# Work Order ID 94355

Item Name: Crosstube Turning Detail

<b>DART AEROSPACE LTD</b>	<b>Work Order:</b>	94355
<b>Description:</b> Crosstube Assembly (412 High Aft)	<b>Part Number:</b>	D412-664-243
<b>Inspection Dwg:</b> D412-664-243 <b>Rev:</b> E		<b>Page 1 of 2</b>

DRAWING NO. D412-664-243	TITLE CROSSTUBE ASSEMBLY (412 HI AFT)	REV. E	<b>DART AEROSPACE LTD ENGINEERING ORDER</b>		D.E.O. NO. D412-664-243-E-1	SHEET NO. SHEET 1 OF 2	SCALE NTS
DRAWN	CHECKED	MFG. APPR.	APPROVED	DE APPR.			
DATE 11.03.31	DATE 11/03/31	DATE 11.03.31	DATE 11/03/31	DATE 11.03.31

**TURNING DETAIL**

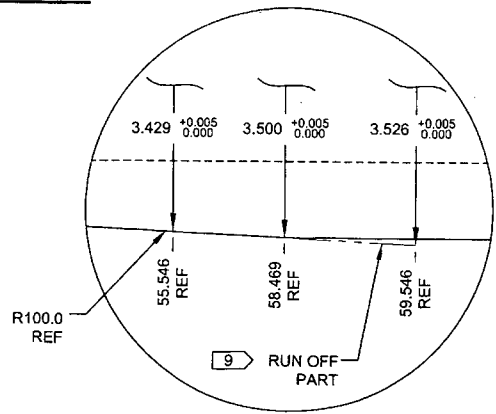
Root Cause	Date	Step	Qty	Description of work order update or Non-conformance	Initial Chief Eng	Action Description	Sign & Date	Verification	QC Inspector
Doc/Data <input type="checkbox"/>	13/1/15	100	1	Cuffs are Machined too Large.	DAS 12 2-89 13/1/15	Max of $\phi 2.999$ Acceptable. Saddle fits OK	13/1/15 13-03-11	13-03-11	DAS 16 2-89 13/3/11
Equip/Tooling <input type="checkbox"/>									
Operator <input type="checkbox"/>									
Material <input type="checkbox"/>									
Setup <input type="checkbox"/>									
Other <input type="checkbox"/>									
Process <input type="checkbox"/>									
Supplier <input type="checkbox"/>									
Training <input type="checkbox"/>									
Unapproved <input type="checkbox"/>

D412-664-243  
ASSEMBLY DETAIL

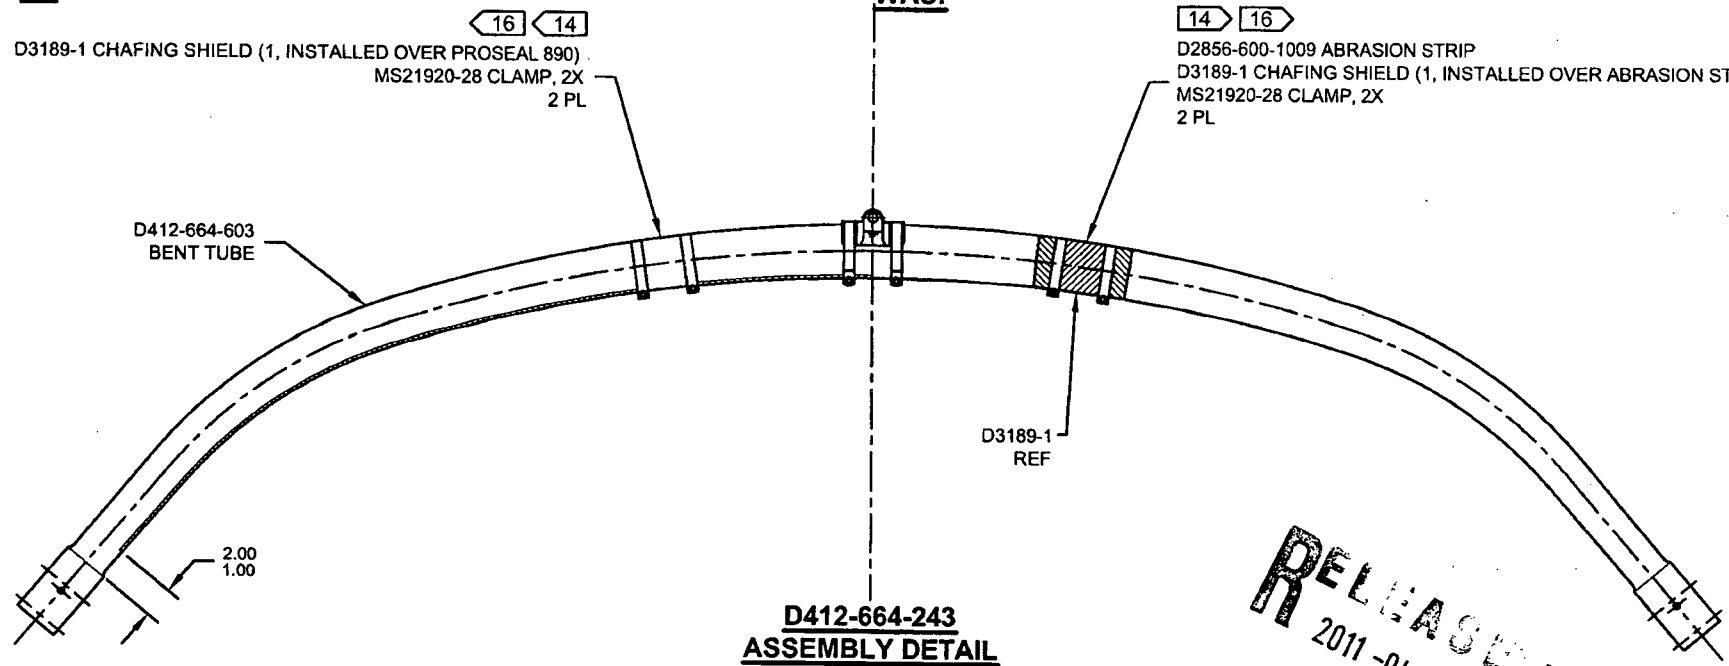
DRAWING NO. D412-664-243	TITLE CROSSTUBE ASSEMBLY (412 HI AFT)	REV. E	DART AEROSPACE LTD ENGINEERING ORDER	D.E.O. NO. D412-664-243-E-1	SHEET NO. SHEET 2 OF 2	SCALE NTS
DRAWN	CHECKED	MFG. APPR.	APPROVED	DE APPR.		
DATE 11.03.31	DATE 11.03.31	DATE 11.03.31	DATE 11.03.31	DATE 11.03.31

IS:

D3189-1 CHAFING SHIELD (1, INSTALLED OVER PROSEAL 890)  
MS21920-28 CLAMP, 2X  
2 PL

WAS:

D2856-600-1009 ABRASION STRIP  
D3189-1 CHAFING SHIELD (1, INSTALLED OVER ABRASION STRIP)  
MS21920-28 CLAMP, 2X  
2 PL

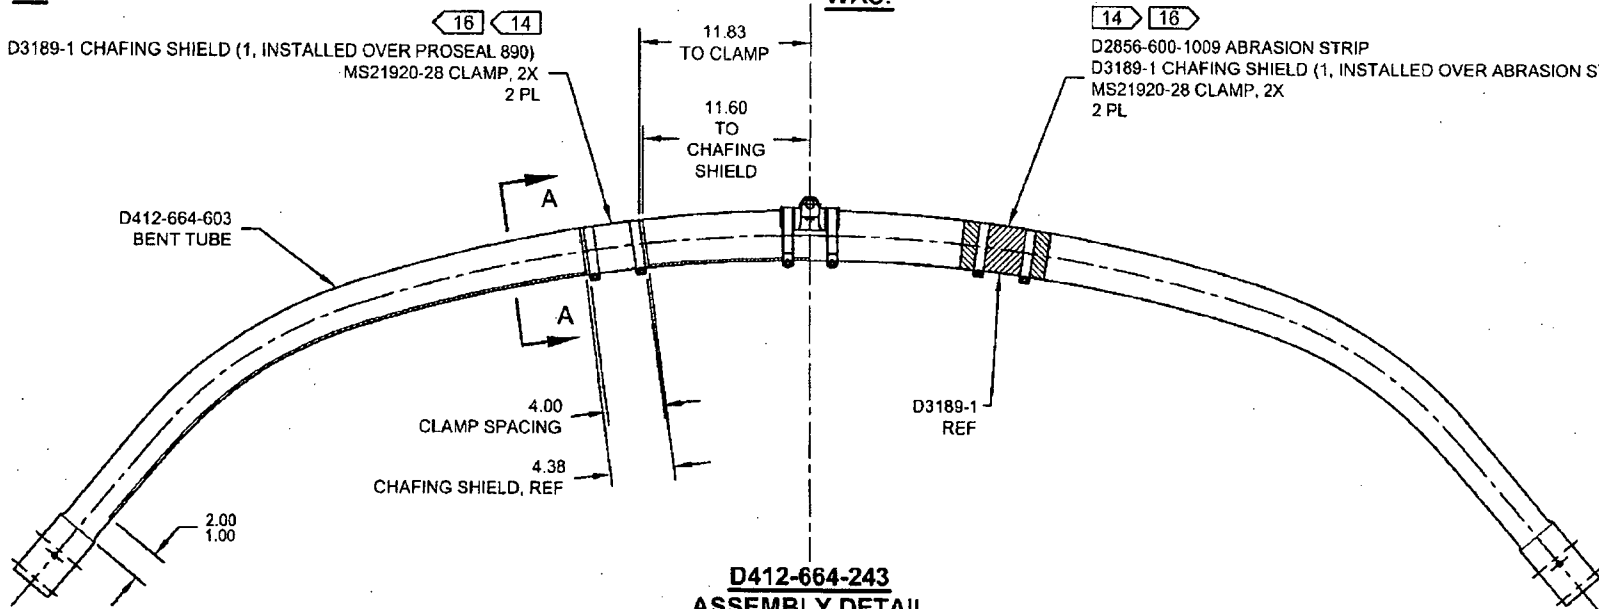
REMOVED ABRASION STRIP IN FAVOR OF A THIN LAYER OF PROSEAL 890. UPDATE INSTALLATION OF CHAFING SHIELDS AND REDUCE TORQUE TO 40-50 IN-LBS. THIS ENGINEERING ORDER SUPERCEDES DEO D412-664-243-E-1.

NOTES 2, 14, AND 16 ON SHEET 1 ARE AMENDED AS FOLLOWS:

- 2) FINISH: CHEMICAL CONVERSION COAT PER DART QSI 005 4.1  
PRIME INSIDE AND OUTSIDE PER DART QSI 005 4.2  
MASK UNDERSIDE OF CROSSTUBE AS SHOWN (HATCHED AREA)  
PAINT OUTSIDE PER DART QSI 005 4.2  
AFTER PAINTING, APPLY CLEAR COAT ON HATCHED AREA
- 14) APPLY A THIN COAT OF PROSEAL 890 ON INSIDE CONCAVE SURFACE OF D3189-1 CHAFING SHIELD AND LET CURE PER MANUFACTURER'S INSTRUCTIONS. INSTALL PROSEALED D3189-1 CHAFING SHIELD ONTO CROSSTUBE BY APPLYING A THIN COAT OF PROSEAL 890 ONTO CROSSTUBE. BE SURE TO ELIMINATE ANY AIR GAPS.
- 16) TORQUE CLAMPS ON D2896-1 SUPPORT 80 TO 100 IN-LB. **TORQUE CLAMPS ON D3189-1 CHAFING SHIELD 40 TO 50 IN-LB.** ENSURE AT LEAST 1.5 THREADS SHOWING IN SAFETY AND THAT NUT HAS NOT BOTTOMED-OUT AFTER TORQUING.

- 2) FINISH: CHEMICAL CONVERSION COAT PER DART QSI 005 4.1  
PRIME INSIDE AND OUTSIDE PER DART QSI 005 4.2  
PAINT OUTSIDE PER DART QSI 005 4.2
- 14) INSTALL D2856-600-1009 ABRASION STRIPS WITH A 0.13 REF GAP ON BOTTOM SIDE OF CROSSTUBE PER QSI 035.
- 16) TORQUE CLAMPS 80 TO 100 IN-LB. ENSURE AT LEAST 1.5 THREADS SHOWING IN SAFETY AND THAT NUT HAS NOT BOTTOMED-OUT AFTER TORQUING.

**D412-664-243  
ASSEMBLY DETAIL**

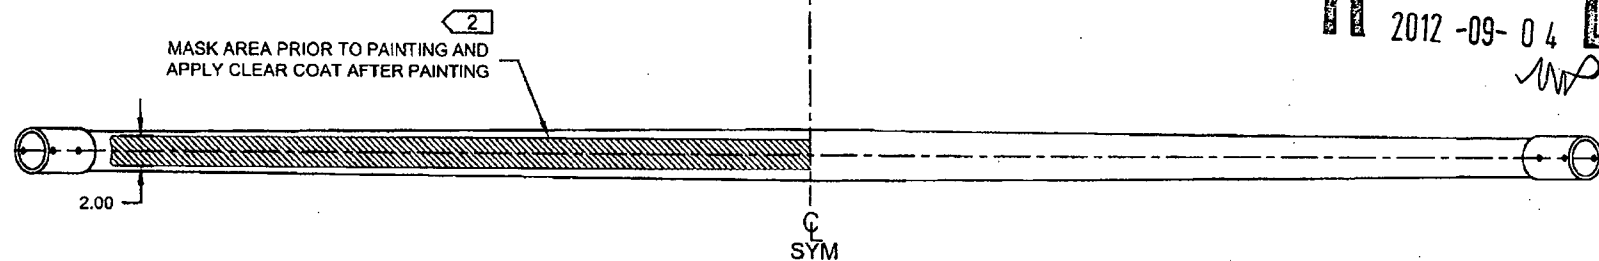
**IS:**

D3189-1 CHAFING SHIELD (1, INSTALLED OVER PROSEAL 890)  
MS21920-28 CLAMP, 2X  
2 PL

**WAS:**

D2856-600-1009 ABRASION STRIP  
D3189-1 CHAFING SHIELD (1, INSTALLED OVER ABRASION STRIP)  
MS21920-28 CLAMP, 2X  
2 PL

**SECTION A-A**  
CHAFING SHIELD DETAIL  
VIEW ROTATED, NOT TO SCALE

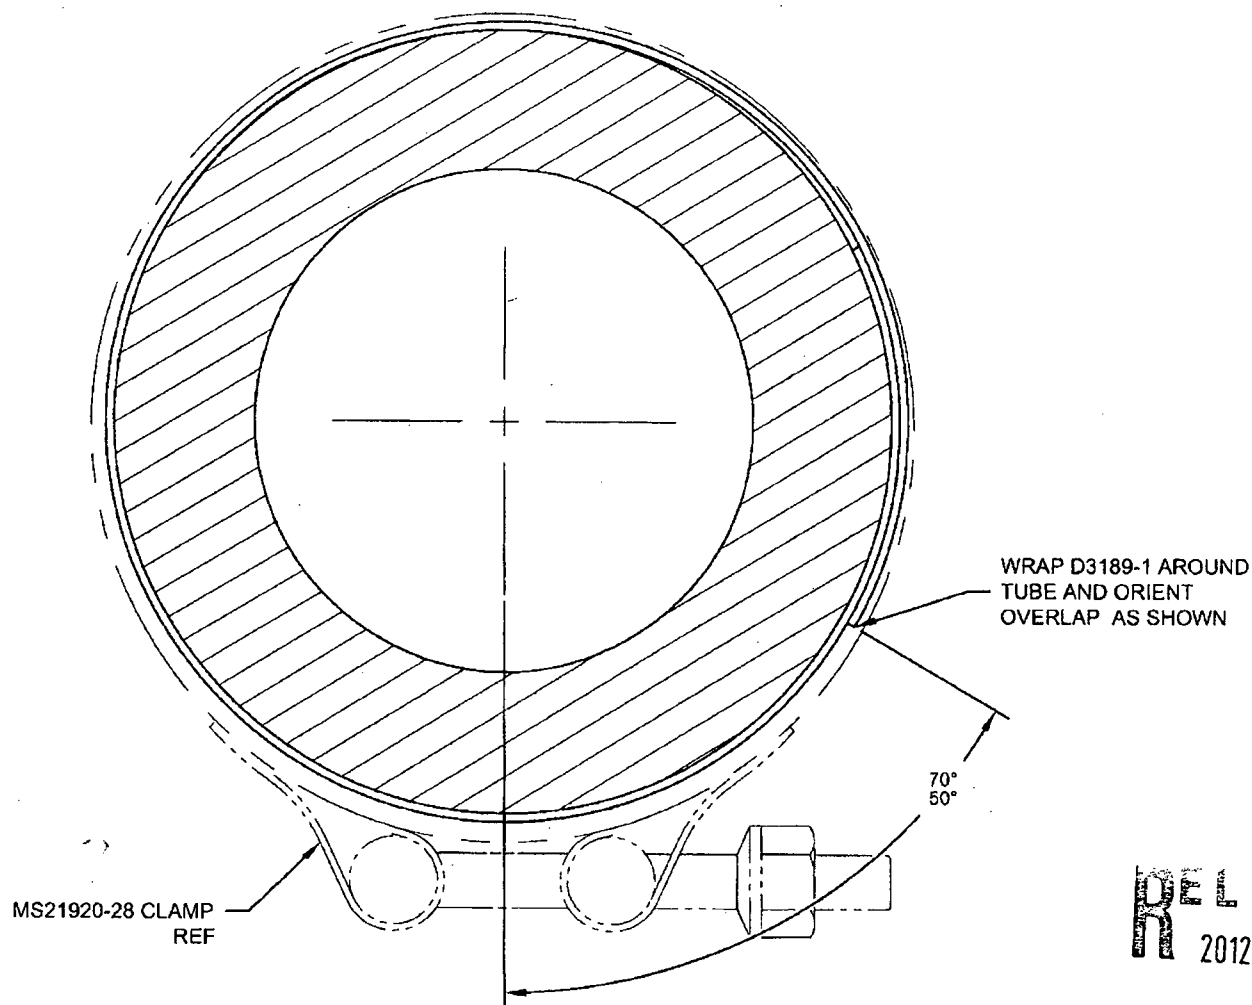
DRAWING NO. D412-664-243	TITLE CROSSTUBE ASSEMBLY (412 HI AFT)	REV. E	DART AEROSPACE LTD ENGINEERING ORDER		D.E.O. NO. D412-664-243-E-4	SHEET NO. SHEET 3 OF 3	SCALE NTS
DRAWN 92	CHECKED	MFG. APPR.	APPROVED	DE APPR.			
DATE 12.08.21	DATE 12.08.22	DATE 12.08.29	DATE 12.08.29	DATE 12.08.29	DATE 12.08.29
